# Hybrids Phase 3: Manual 10 and 14D Changes

Operating Committee  
June 3, 2025

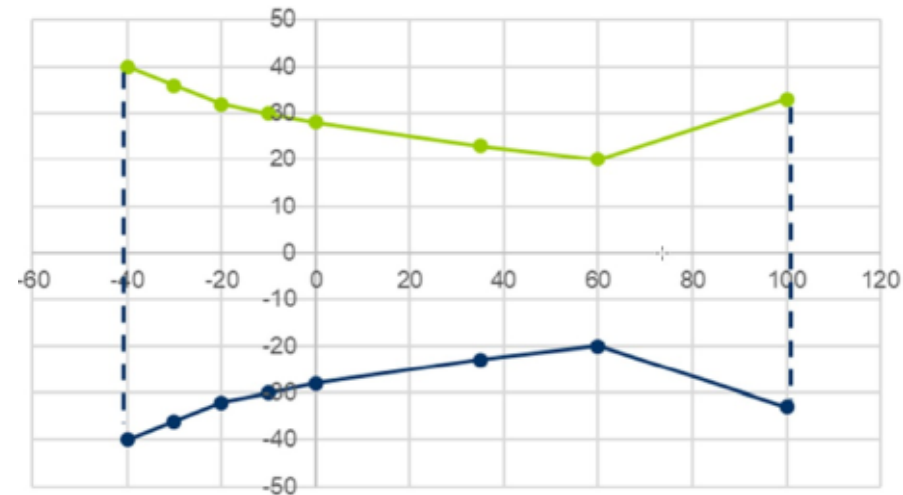
- Section 13.1 Marketing and Classification of Mixed Technology Facilities
  - Modified language to broaden eligibility to participate as a Hybrid Resource
  - Clarified classifications of open-loop and closed-loop based on definition changes
  - Updated language and diagram to be inclusive of all eligible resource types for hybrids
  - Updated language to specify when a Mixed Technology Facility must participate as a Hybrid Resource
  - Noted classification of closed-loop for any Hybrid Resource without storage component
  - Clarified that for all Mixed Technology Facilities participation change notifications must be made no later than six (6) months in advance of its initial start in the energy markets.
